Re: Marais Oxidation Pond Sewer
Treatment Rehabilitation OCD/DR
Number 04PARA2309 (Funding by
Louisiana Office of Community
Development/Disaster Recovery Unit
OCD G/I Project No. 04PARA2309)

ADDENDUM NO. 1

PROJECT: Marais Oxidation Pond Sewer Treatment Rehabilitation
OCD/DR Number 04PARA2309 (Funding by Louisiana Office
of Community Development/Disaster Recovery Unit OCD G/
Project No. 04PARA2309)

3.) REMOVE- EXISTING SHEET C.5 SEWER TREATMENT PLANT PLAN.

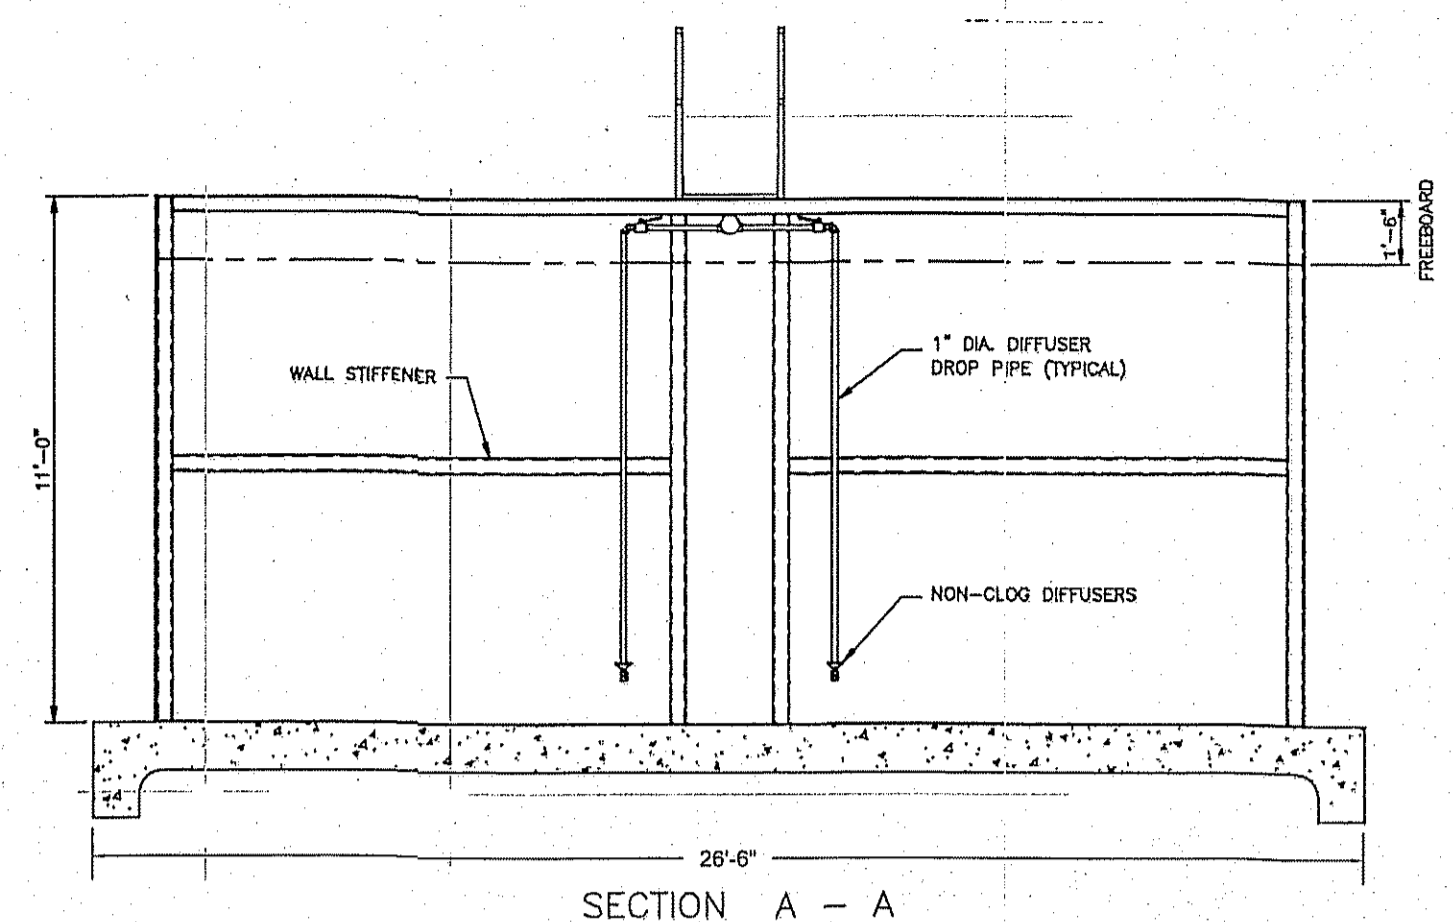
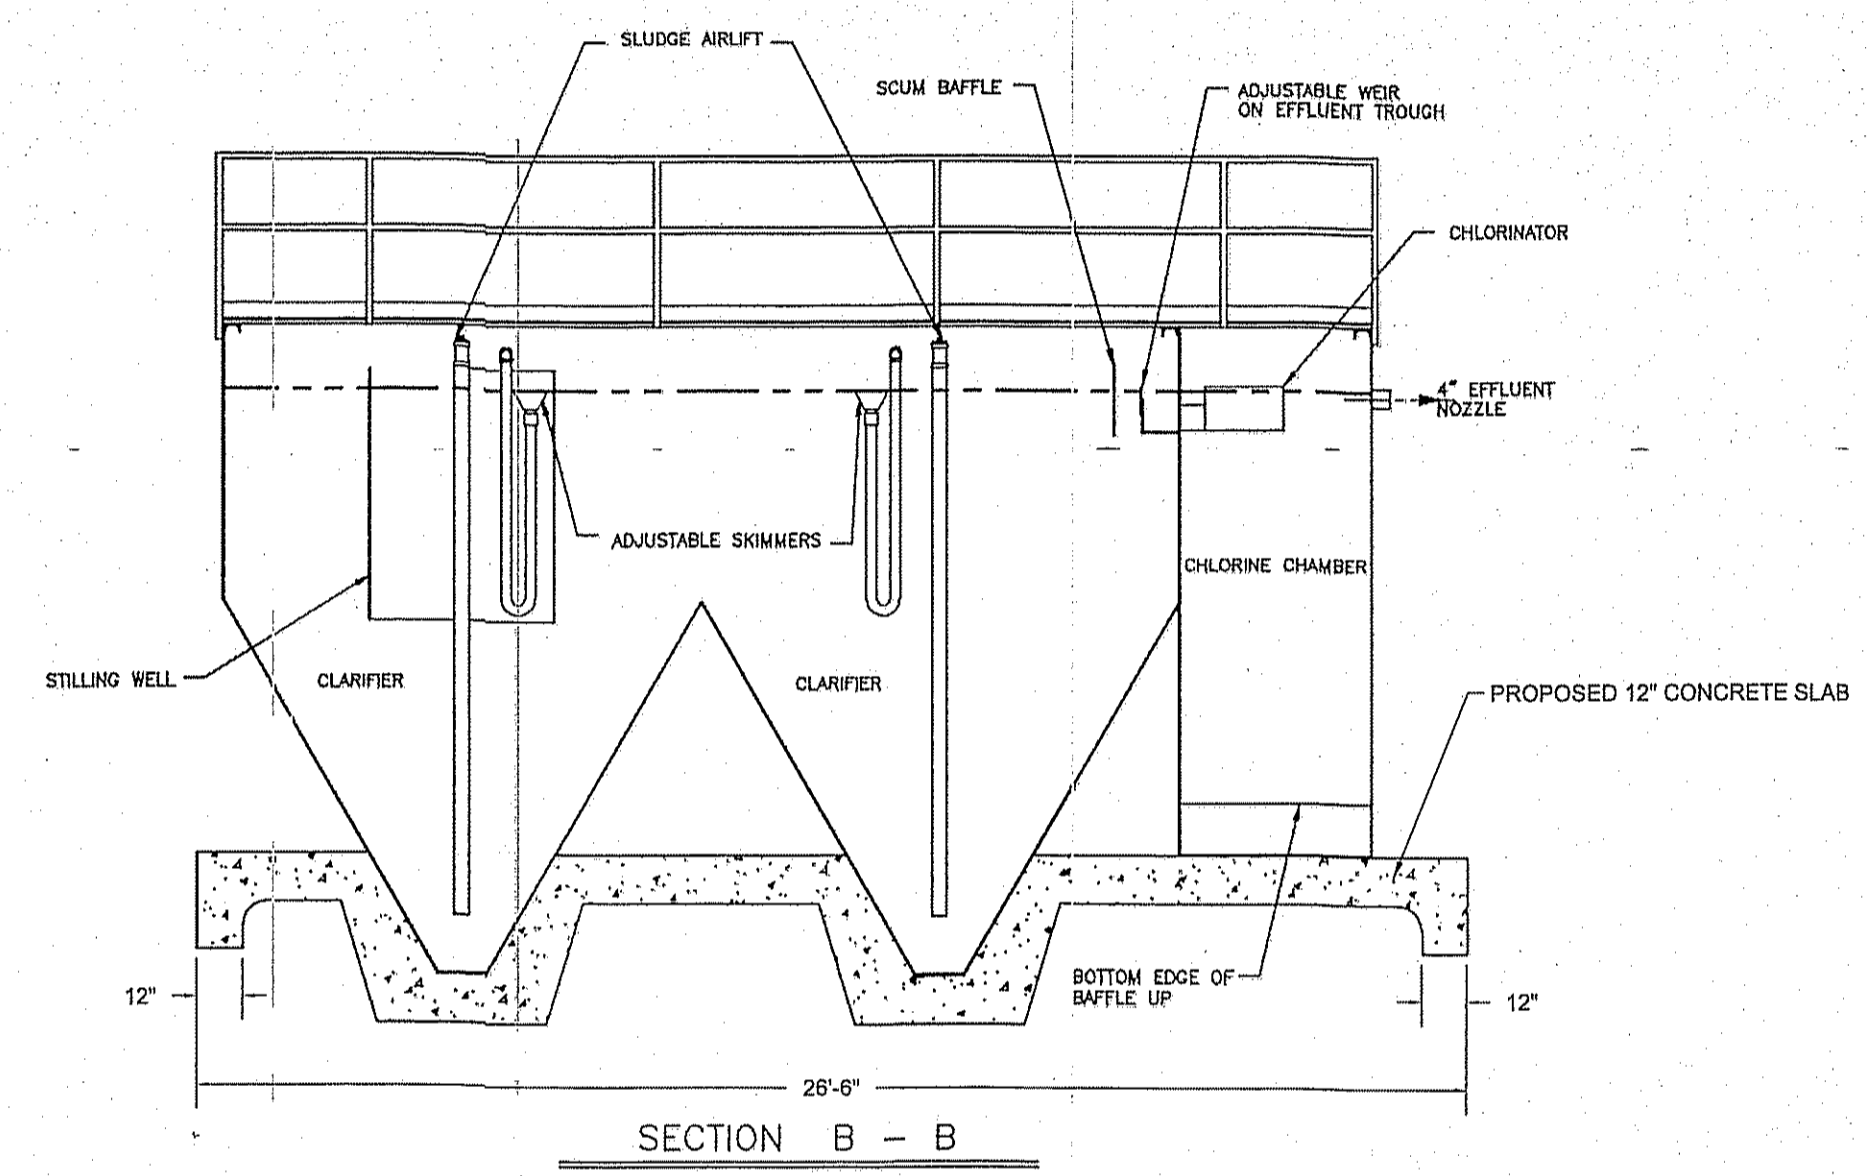
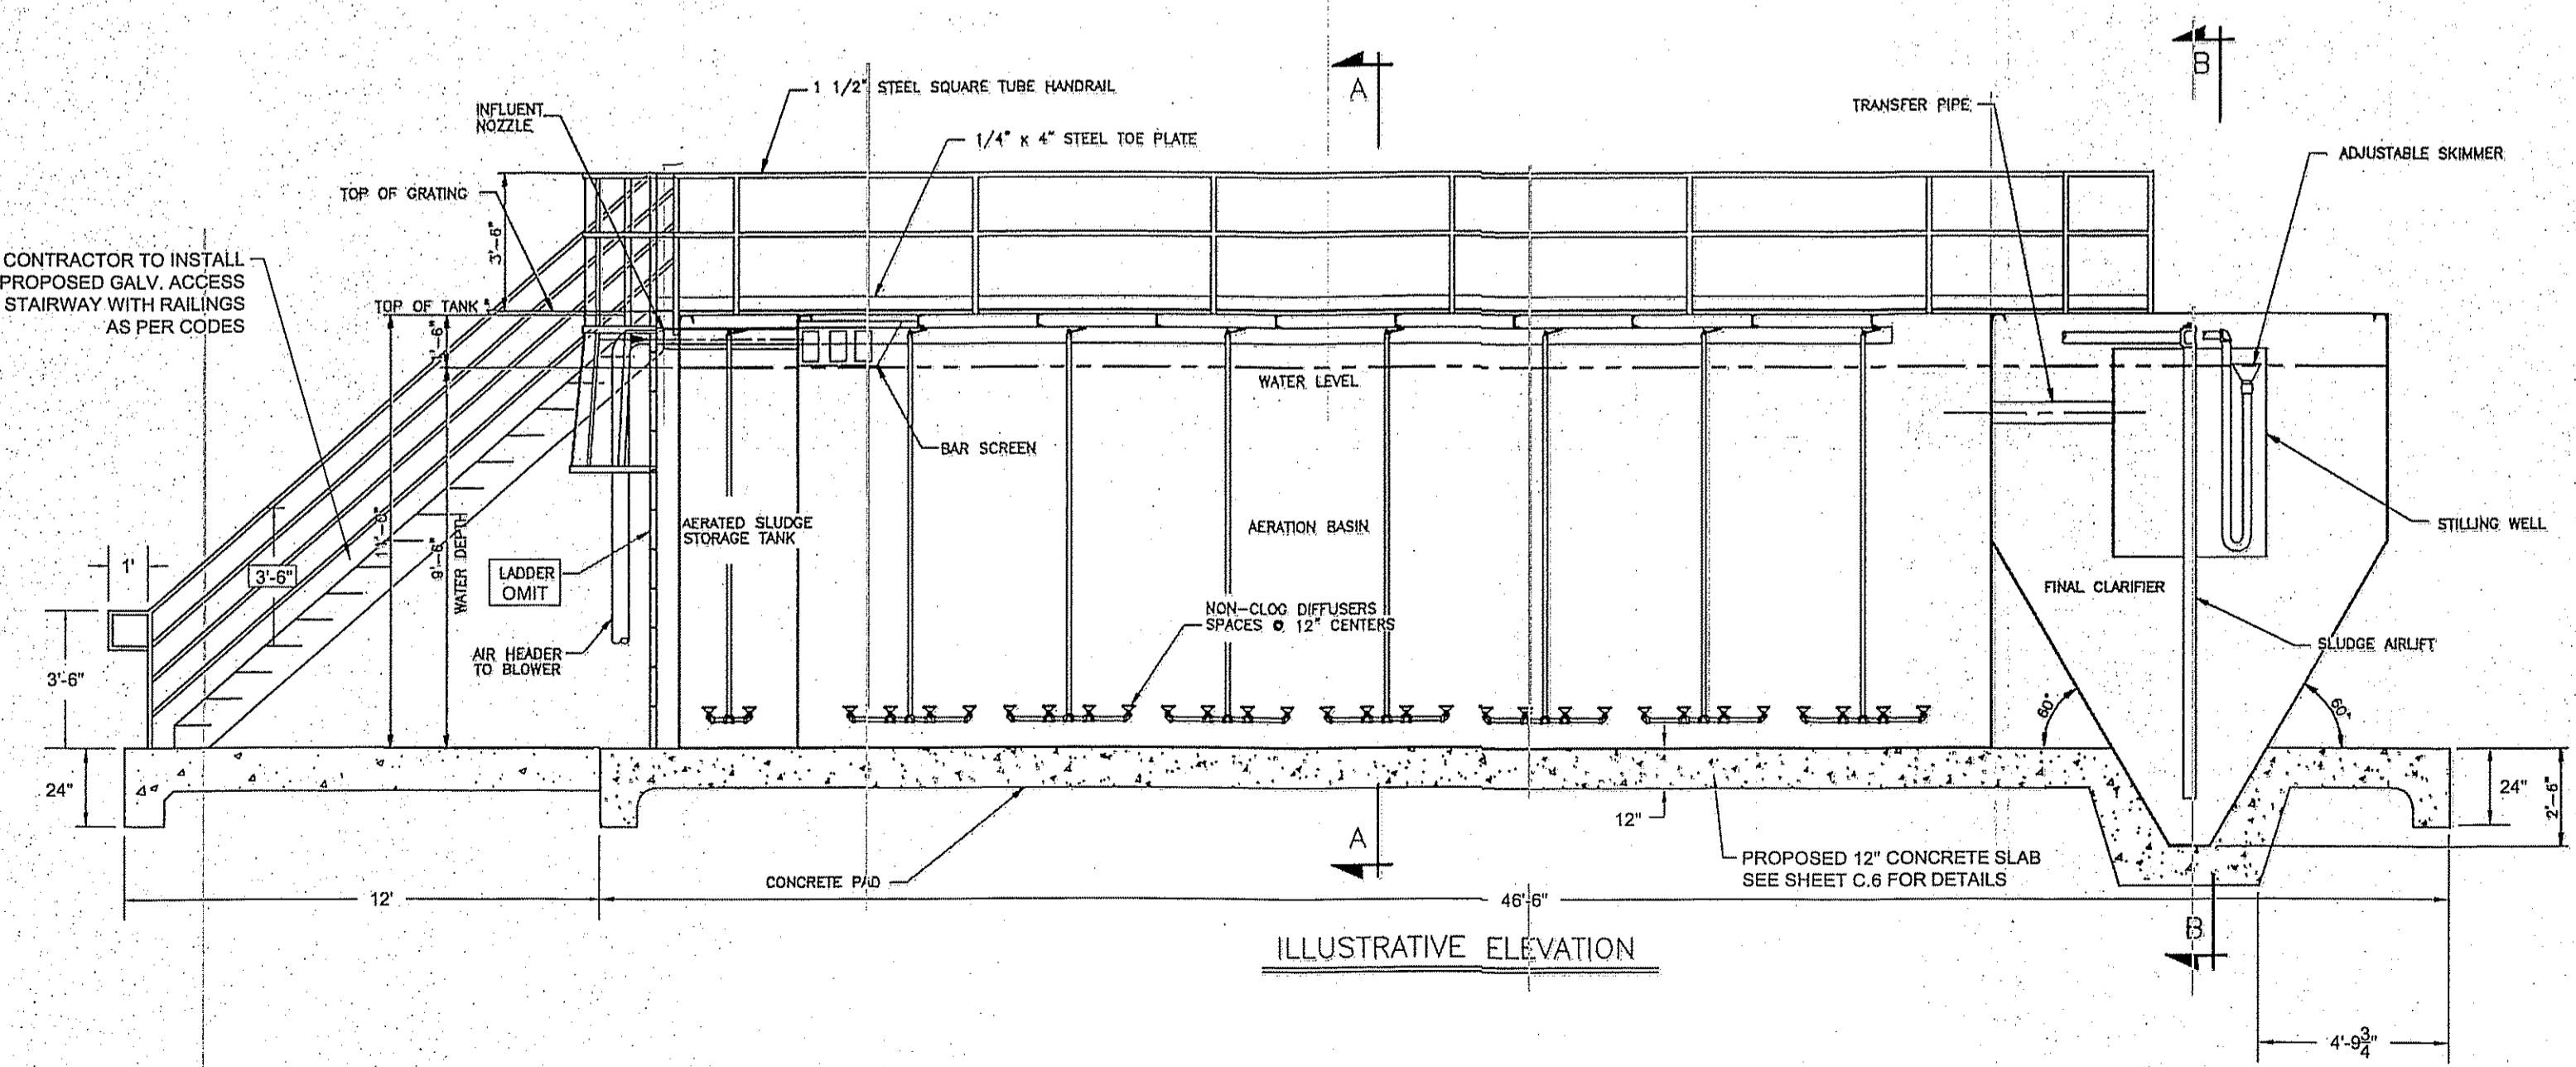
NOTE: AIR BLOWERS AND PLANT ELECTRICAL CONTROLS SHALL BE SINGLE PHASE.

REPLACE- ATTACHED REVISED SHEET C.5 SEWER TREATMENT PLANT PLAN.

| EXTENDED AERATION PLANT | |
|---|-------------|
| AERATION BLOWERS (15 hp, 1 PHASE, 60 CYCLE, 460V) | 320 CFM |
| CONTROL PANEL (1 PHASE, 60 CYCLE, 230 VOLT, 4 WIRE) | |
